Roof study · the maintenance ladder, the lowered attic, the low parapet with the set-back guardrail, the main cornice, the reserved zones · Taif / Palm House V8.1

Design review F-07 (major) · owner decisions 31 Oct 2026, V8.0 and V8.1 (the maintenance ladder, the roofline lowered) · flat roof, no tiles · the roof for maintenance and equipment only · no slab level changes · all sizes assumed until the engineer, the ladder supplier and the fall-protection specialist confirm

1 · Roof plan: what is on the roof

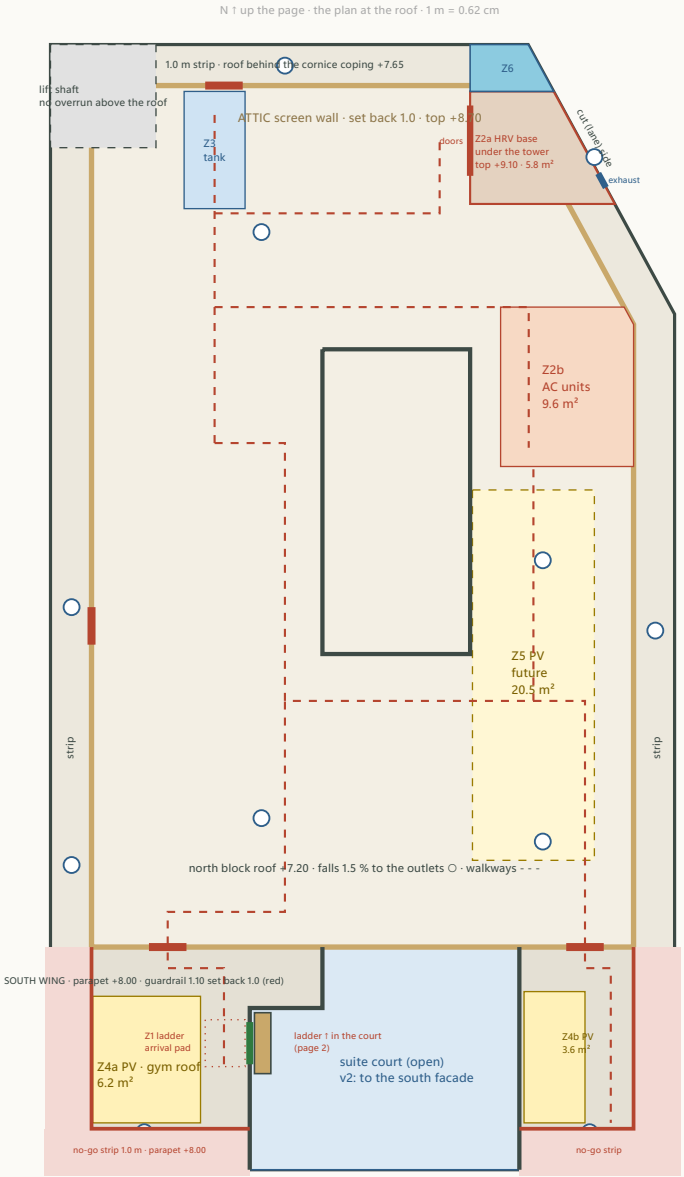
- **Access (owner, V8.1):** the roof is reached by a **fixed maintenance ladder Z1 in the suite court** (page 2): 3.7 m from the court floor +3.60 to the gym roof +7.30, in a recess in a stone pilaster on the gym's east wall, behind a locked panel; a self-closing gate in the court's west guard at the top. Workers reach it through the house (gym → court). The main stair stops at the first floor and the roof slab over its well is closed; no door from the roof into the house. The lift stops at the first floor; its shaft needs no head above the roof (§ 5).

- **Attic (lowered):** a screen wall 1.4 m above the roof finish, coping included (top +8.70 was 1.80 / +9.10), set back 1 m from the facade face on the north, the cut (lane), the east and the west sides (a plain pentagon); its south wall stands on the y 19.25 line (beams B8 / R5). Length ≈ 57.8 m. Two openings to the strip (north, west; gated and locked) and two to the south wing roofs (x 2.1–2.9 and x 11.0–11.8).

- **The 1.0 m strip** (Z7) in front of the attic: roof behind the main cornice and its low coping, with its own outlets; a no-go zone (harness).
- **South wing** (y 19.25–24): the main cornice and a **low visible parapet** 0.7 m above the finish (top +8.00 was 1.10 / +8.40); the fall protection is a **continuous 1.10 m black steel guardrail set back 1 m** from the west, south and east faces (red), running from the attic's end walls to the court guards: not seen from the street; the strip between it and the parapet (Z8) is a no-go zone. The roofline steps 0.7 m down from the attic coping.

The roof access · the maintenance ladder in the suite court (owner, V8.1) · enlarged plan and section · the main stair stops at the first floor

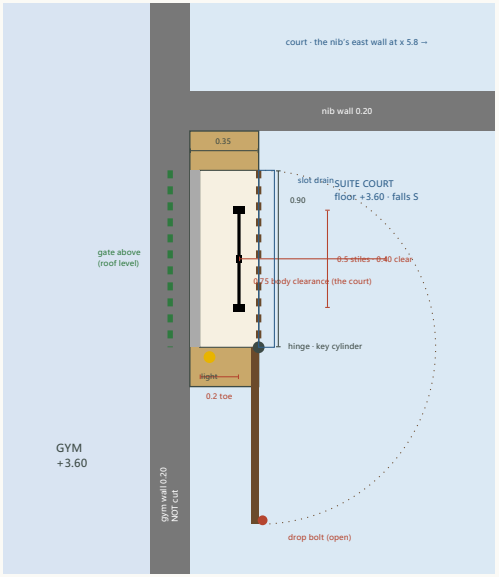
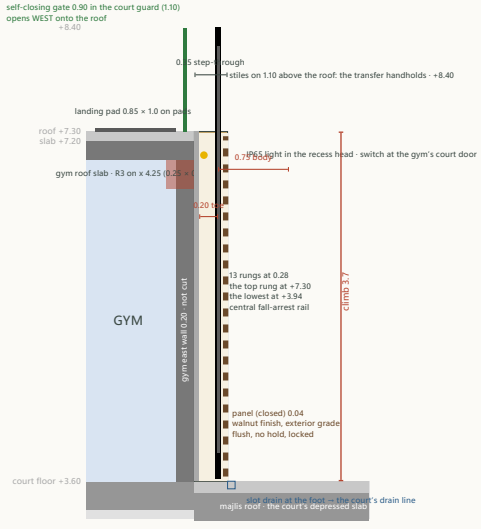
- **Owner's decision (V8.1):** a simple roof access (cost and appearance); office visitors are met in the men's majlis, the office is the owner's only, reached from the suite court. The roof is reached by a **manufactured vertical fixed ladder** (not site-made; black matte, non-slip rungs, corrosion-protected, aluminium or hot-dip galvanised and powder-coated steel) in the suite court, on the **gym's east wall**, at the north end of the wall against the nib: away from the seating (y ≥ 21.7) and off the door strip (y ≤ 20.55, x ≥ 5.9).

- **The recess:** 0.9 wide × 0.3 deep, full height from the court floor +3.60 to the gym roof +7.30, formed in a **honey-stone pilaster added on the court face of the wall** (1.3 × 0.35 m, cheeks 0.20): the 0.20 m structural wall on B19 (under R3) is **not cut**. If the engineer confirms that wall as non-load-bearing infill between B19 and R3, the recess may instead be cut into a locally rebuilt 0.50 wall and the pilaster disappears (structural coordination, X20). The pilaster's own weight (≈ 1.7 m³ block ≈ 20 kN) stands on the court's depressed slab: the engineer.

- **The ladder:** stiles 0.5 overall, rungs 0.40 clear, pitch 0.28, 13 rungs, the **top rung level with the roof finish** (+7.30), the lowest 0.34 above the floor; **toe clearance 0.2 m** behind the rung line (≥ 0.18), **body clearance ≥ 0.75 m** in front of it (the court, with the panel open); climb **3.7 m**. The stiles run on **1.10 m above the roof** (+8.40) as the transfer handholds (fixed, so no retractable grab post; if one is preferred it is mechanically fixed, never friction-held). Tools go up in a bag: both hands on the ladder.

- **The panel:** exterior-grade walnut-finish (marine ply or aluminium composite with a walnut veneer, 0.04 thick), hinged on the south jamb, **opens 180°** to lie flat along the pilaster line (x 4.7, y 21.75–22.65), held open by a **floor drop-bolt** away from the climber; a key cylinder outside (the key with the parents / the maintenance key); **closed it is flush with the pilaster face and offers no hold**: not climbable (children). With the panel closed the court reads a walnut panel in a stone pilaster, in the design language.

- **The arrival on the roof:** the climber steps from the top rung over the pilaster's top (0.35) through a **self-closing gate 0.90 in the court's west guard** (1.10 m, on x 4.25, directly above the recess), opening **west onto the gym roof**, onto a **standing landing pad** (x 3.3–4.15, y 20.8–21.8) inside the protected zone; from it the walkway north to the attic opening. The guarding is continuous from the pad to every piece of equipment (§ 3 check); the strip outside the set-back guardrail is a no-go zone.

- **Fall protection:** the climb (3.7 m) is over the 3.0 m threshold of EN ISO 14122-4: the ladder is specified with a **central fall-arrest rail** (EN 353-1 glider) rather than a cage, which would not fit the recess; the specialist confirms the arrangement under the Saudi requirements (SBC / Civil Defense / the labour safety rules) — **not verified here**. Anchor eyes on the attic wall for the no-go strips.

Sight lines · north–south section at x ≈ 1.4, looking west · the attic 1.4 m above the finish, set back 1 m · the parapet 0.7 m and the set-back guardrail · eye 1.6 m above the ground

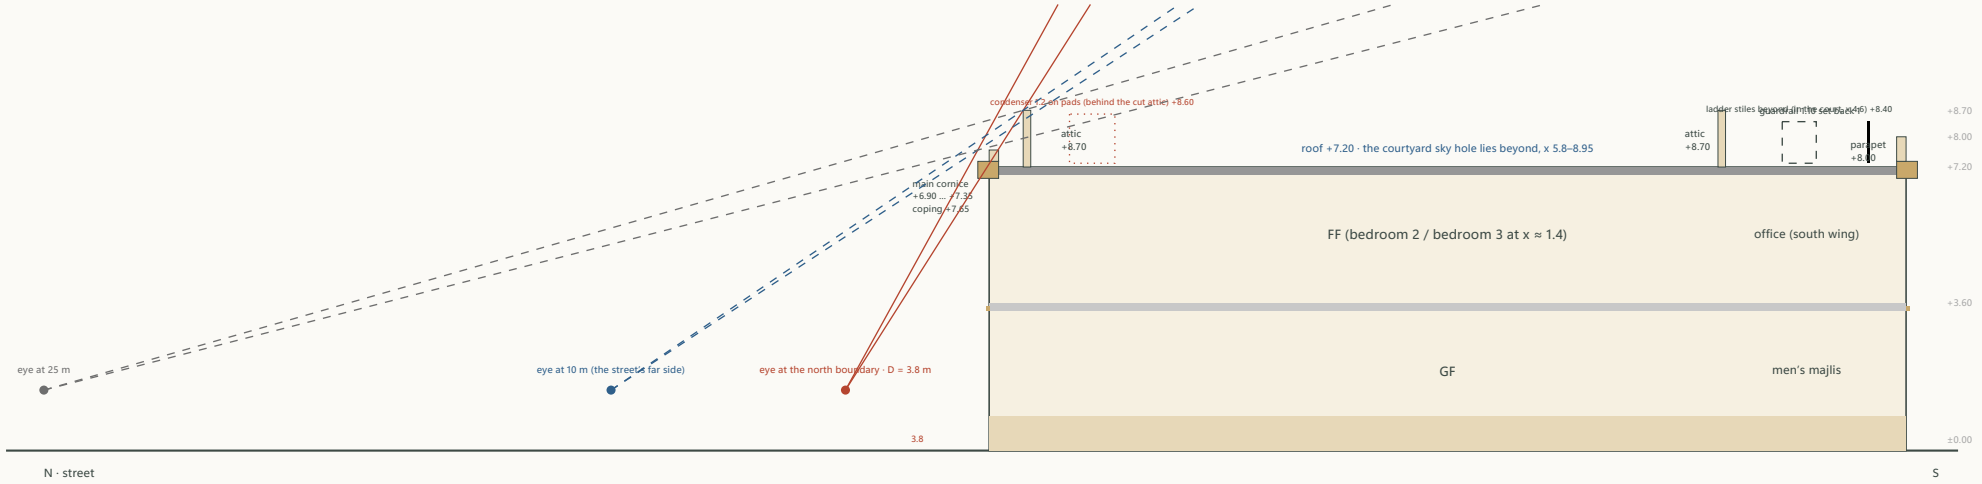
- **Attic height (owner, V8.1): 1.4 m above the roof finish, coping included** (top +8.70 was 1.80 / +9.10). **Re-run:** the minimum that hides the condensers from the street and the lane at eye level from every distance is 1.3 m (1.2 m units on 0.10 pads: top +8.60); 1.4 m leaves 0.10 m of margin, so **1.40 m works** on the condition that the outdoor units are **≤ 1.2 m high** (most 2–7 kW split and VRF condensers are 0.6–1.0 m; a tall unit laid on its side is not allowed: specify the height to the MEP engineer). The tank 1.0 m: hidden with 0.40 m of margin.

- **The HRV base** (+9.10) now stands 0.4 m above the attic coping: it is on the facade line in the cut tip, the plinth of the malqaf mass (seen by design, like the head). **Option** (owner / MEP): lower it to +8.70 with 1.25 m clear inside and 1.1 m doors (a horizontal unit ≤ 0.7 m); drawn: kept at +9.10 (1.65 m clear). The ladder's stiles (+8.40, in the court 2.4 m behind the court's south face) stay below the attic coping and are hidden from the south garden by the parapet up to ≈ 40 m; black matte.

The cornice and the attic in section · loads for the engineer · what changes in the files

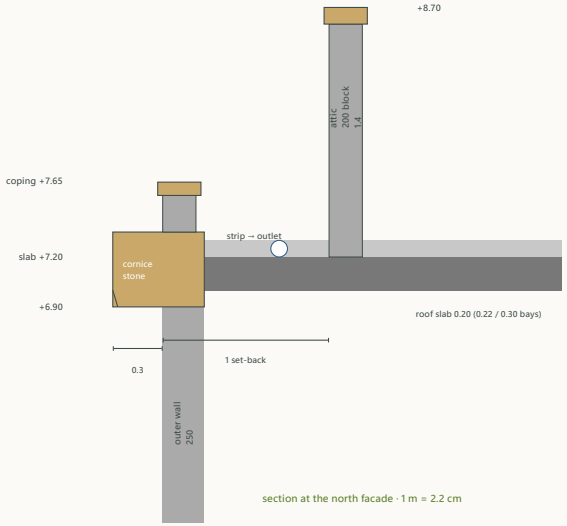
- **Attic (lowered V8.1):** 200 mm block, plastered cream, stone coping; 1.4 m above the roof slab + 0.10 coping = 1.4 m above the finish (coping +8.70); set back 1 m from the facade face (0.88 m from the wall centre lines); ≈ 57.8 m long; on the south on the y 19.25 line (B8 / R5). Four openings 0.80 (two to the strip, gated and locked; two to the south wing roofs).

- **South wing parapet:** 0.7 m above the finish, coping included (top +8.00); the **guardrail** 1.10 m black steel bars (posts at 1.5 m) set back 1 m from the outer faces, continuous from the attic's end walls to the court guards; the no-go strips 1.0 m.

- **Roofline step:** 0.7 m at y 19.25 (attic coping +8.70 → parapet +8.00), plus the 1.0 m plan set-back. **Final heights:** cornice +6.90 … +7.35, north coping +7.65, south parapet +8.00, attic coping +8.70, HRV base +9.10, malqaf head +9.80, ladder stiles +8.40 (inside the court). Targets, to confirm at the facade design stage.
